Access Compliance Report Public Rights-of-Way (Curb Ramps)

Main Street: 17TH_ST Cross Street: HOLT_AVE Location: S

ADA ID: RPRK211007145956 Ramp Type: Type 1 - Perpendicular Diagonal Initial Pass/Fail: Fail Overall Compliance: No Severity Score: 30

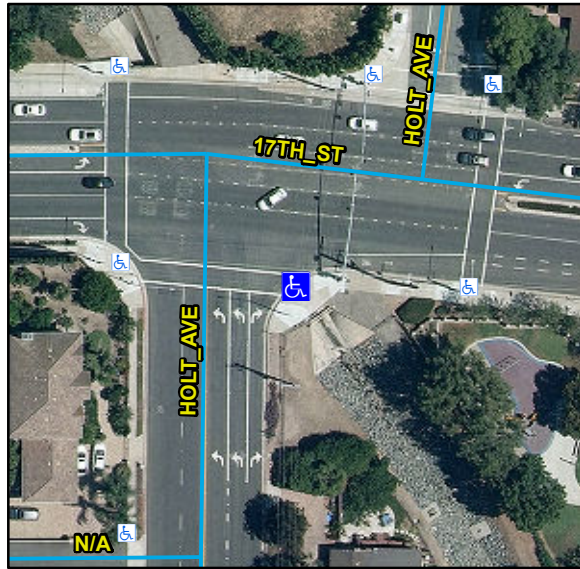
Compliance	Description	Data	Compliance	Description	Data
N/A	Ramp Length (in)	130	N/A	Flare Type LT	
Yes	Ramp Width (in)	48			N/A
No	Ramp Run Slope (%)	12.3	N/A	Flare Slope LT (%)	N/A
Yes	Ramp Cross Slope (%)	0	N/A	Flare Traversable LT	N/A
N/A	Landing Present	N/A	N/A	Flare Type RT	
N/A	Landing Length (in)	N/A			N/A
N/A	Landing Width (in)	N/A	N/A	Flare Slope RT (%)	N/A
N/A	Landing Run Slope (%)	N/A	N/A	Flare Traversable RT	N/A
N/A	Landing Cross Slope (%)	N/A	N/A	DWS Provided	N/A
N/A	Landing Movement Obstructed?	N/A	N/A	DWS Contrast	N/A
	Landing Movement Type	N/A	N/A	DWS Length (in)	N/A
N/A	Landing Shared	N/A	N/A	DWS Full Width	N/A
N/A	Clear Space	Yes	N/A	DWS Offset Left (in)	N/A
N/A	Clear Space To Crosswalk (in)	N/A	N/A	DWS Offset Right (in)	N/A
N/A	Marked Crosswalk 1	No	N/A	Marked Crosswalk 2	Yes
	Crossing 1 Direction	NE		Crossing 2 Direction	NW
	Marked Crosswalk 1 Width (in)	N/A		Marked Crosswalk 2 Width (in)	146

Remove & Replace Curb Ramp With Two New Directional Ramps or Equivalent.

R304.2.2, STD 1115
